DIABLO CANYON INDEPENDENT SAFETY COMMITTEE

Re: Comment Letter – Once-Through Cooling Policy Special Studies.

Attachment 1
**Diablo Canyon Independent Safety Committee’s Preliminary Evaluation of
Safety Issues for “Addendum to the Independent Third Party Final Technologies
Assessment for the Alternative Cooling Technologies or
Modifications to the Existing Once-Through Cooling System for
the Diablo Canyon Power Plant”**

Fig. 1: Bechtel arrangement for a 44-cell southern cooling tower system.

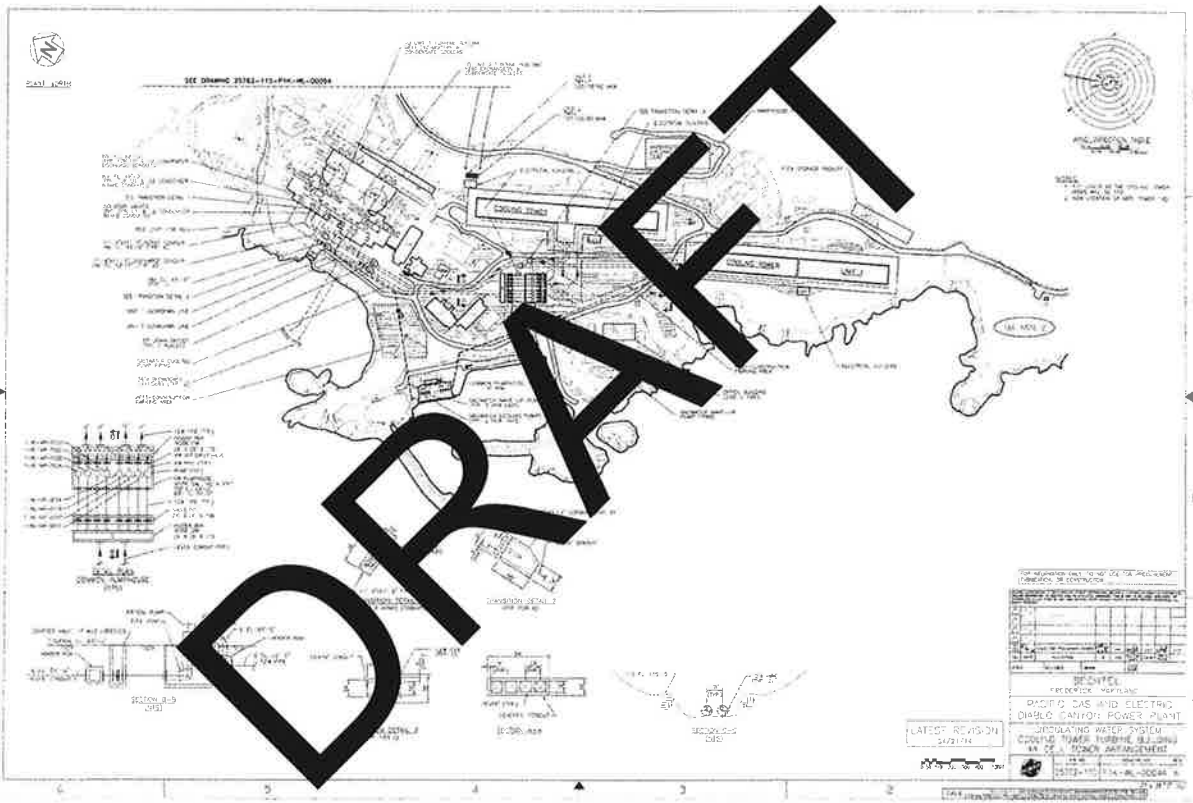
Because the primary access to the plant site is from the south and most of the plant support infrastructure, including parking, security, training, and support buildings are on the south side of the plant, southern siting of cooling towers has the potential to generate more negative impacts on plant operations, emergency response, and safety related systems than northern siting, not only during construction, but also during long-term operation.

The scale of plant modifications required to implement closed cooling with southern siting, and impacts on site access during construction, would be significantly larger than what was required to implement the post-9/11 security changes or for the northern site. It is not clear to the DCISC that the Bechtel construction schedule provides sufficient time to complete rigorous safety reviews, at the level that was performed for earlier security modifications.

DCISC Conclusion 1: The logistics for maintaining effective plant access for normal operations and emergency response, as well as meeting requirements for physical security during the six-year cooling tower construction period prior to the dual-unit outage, will be substantially more complex for the southern siting option.

DCISC Recommendation 1: An evaluation should be performed to understand the impact of southern-sited cooling towers on plant security and emergency response capabilities.

Fig. 2: Wind direction table for the DCPD site in 2013.

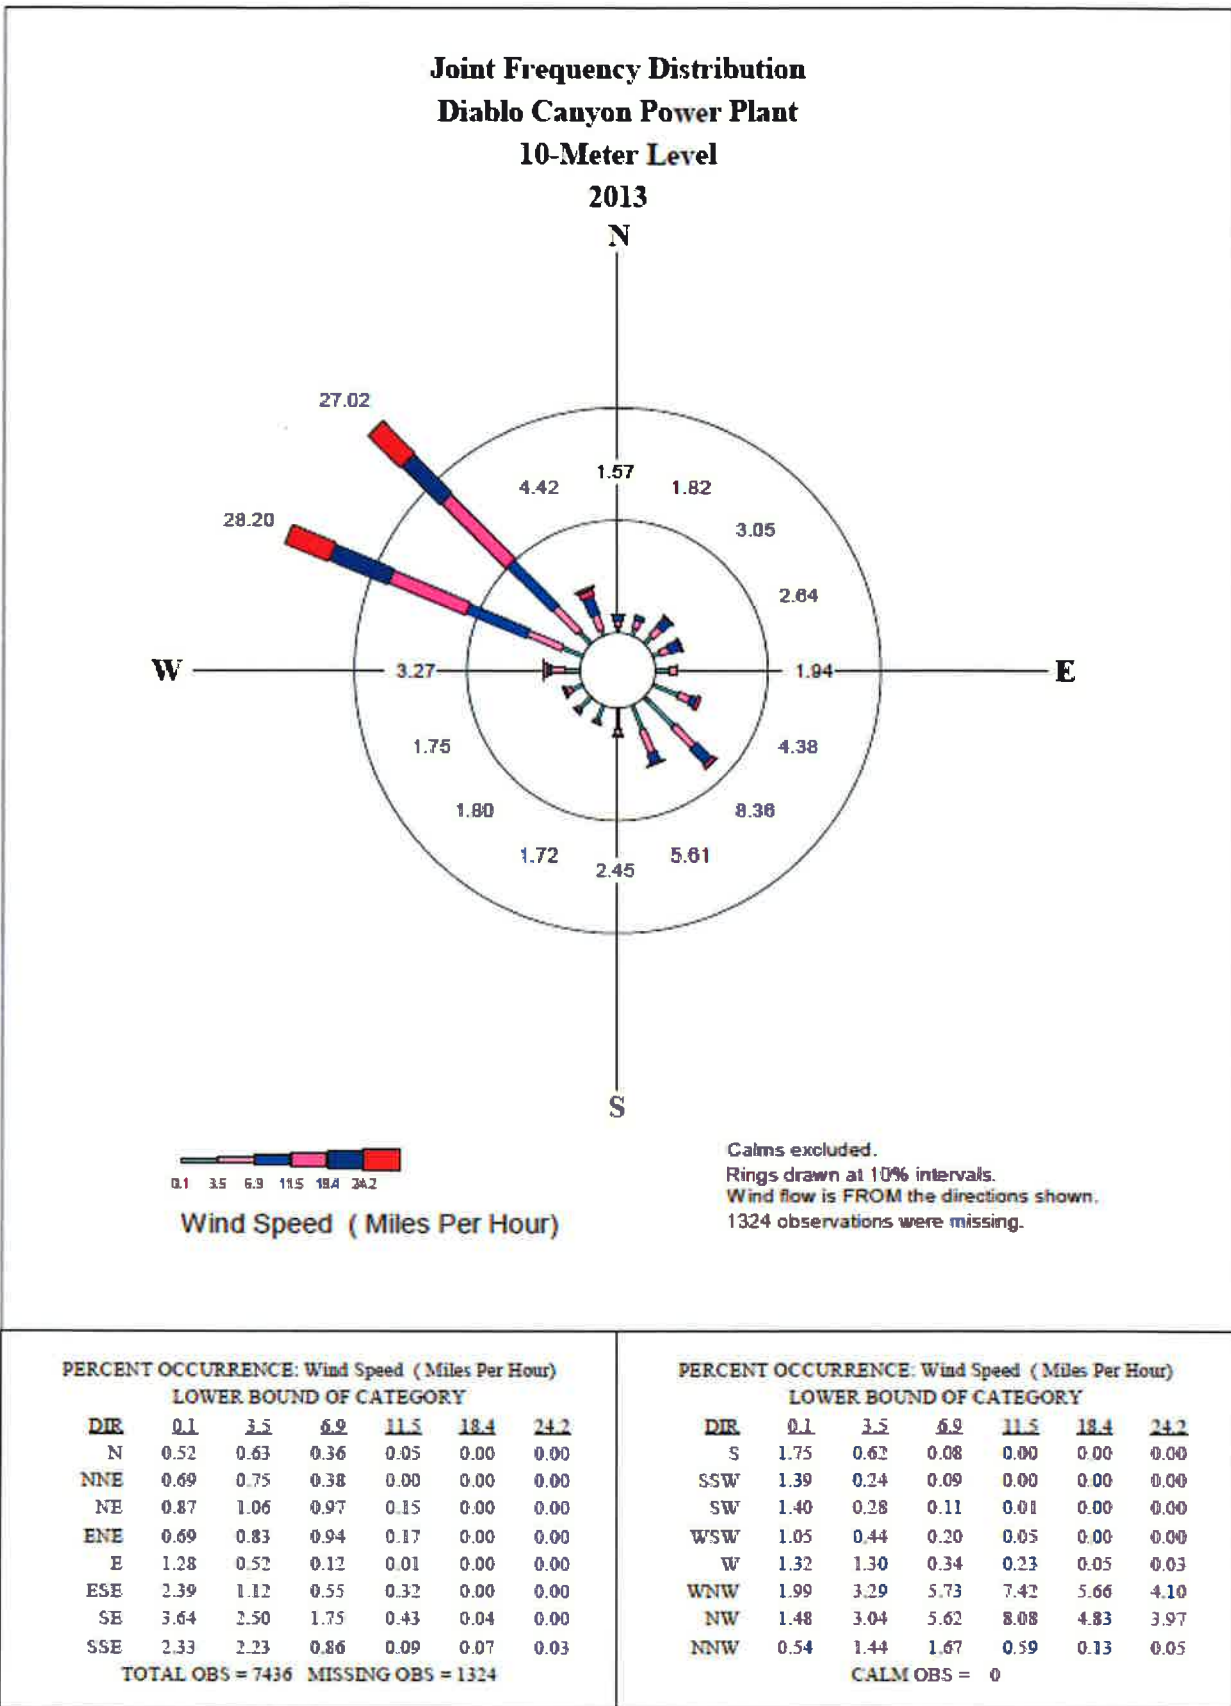
The fraction of the salt contained in this drift flow, that would deposit onto equipment around the plant, depends upon the wind speed, droplet size distribution, and droplet settling velocities. Figure 2 shows a wind direction table (wind rose) for the DCPD site in 2013, which is representative of data for earlier years also (Appendix A). The prevailing winds greater than 3.5 miles per hour (mph) from the west-northwest, northwest and north-northwest would carry droplets away from the plant approximately 55.4% of the time. Approximately 23.3% of the year wind speeds are under 3.5 miles per hour (mph), and approximately 10.1% of the time wind comes from the east-southeast, southeast, or south-southeast at speeds above 3.5 mph, during which times a larger fraction of droplets can be expected to deposit on plant equipment.

DCISC Conclusion 5: The use of salt water cooling towers could result in an increase in the rate of deposition of salt on DCPD plant equipment during the 10.1% of the year that wind blows from the east-south-east and the 23.3% of the year when wind speeds are very low, compared to the rate currently experienced. Higher salt deposition rates have the potential to create negative impacts on some safety-related systems, in particular Emergency Diesel Generators, and ventilation systems for the Auxiliary Building, Control Room, and Fuel Handling Building. Higher salt deposition rates may also reduce the reliability of outdoor high voltage systems that play a major role in plant safety, and increase the frequency of loss of off-site power (LOOP) events. These higher salt deposition rates could also produce negative impacts on the long-term safety of the spent fuel casks in the ISFSI, although these effects should be much less because of the longer distance from the ocean to the ISFSI.

DCISC Recommendation 4: Simulation of rates of salt deposition from salt-water cooling towers, using available modeling tools, should be performed to assess the increase in salt deposition rates that would occur if salt water, rather than fresh water, were used in cooling towers at the site, and these simulations should be used to assess potential impacts on plant safety systems and plant reliability, to inform the decision on whether fresh water or salt water should be used.
